**Amendments to the Drawings**

REMARKS

Claims 13-28 are pending in the application. Claims 13-28 stand rejected. Claims 13, 20 and 27 are amended. Claim 26 is cancelled. No new matter is introduced by way of these amendments.

FIG. 3

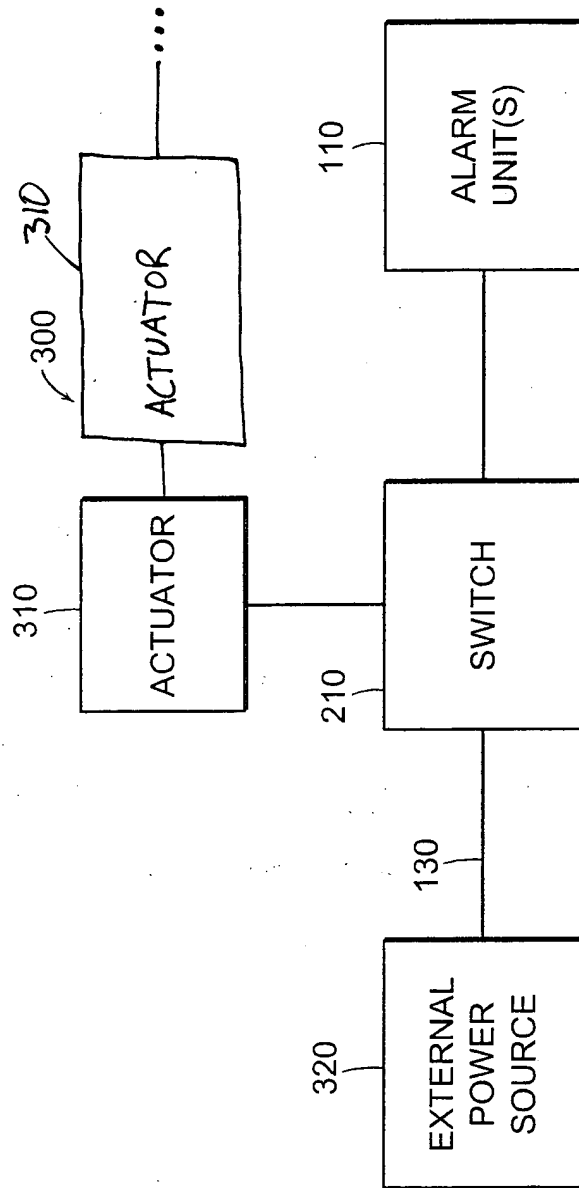
Fig. 3 is being amended to include (i) a second actuator that connects to the first actuator 310 and (ii) ellipses representing other actuators that may connect to the second actuator.

The drawings stand objected to under 37 C.F.R. 1.83(a) because they do not show every feature of the invention specified in Claim 14. Claim 14 recites “at least a second actuator remote from and coupled to the first actuator for providing an alternate location for temporarily interrupting the power supplied to each alarm unit.” Fig. 3 is now amended to include (i) a second actuator that connects to the first actuator 310 and (ii) ellipses representing other actuators that may be connected to the invention system. Support for these amendments is found at page 3, lines 26-28 and page 6, lines 18-19 of the Specification as originally filed. No new matter is being introduced by way of these amendments. Applicants respectfully submit that these amendments overcome the objection to the drawings. Acceptance is respectfully requested.
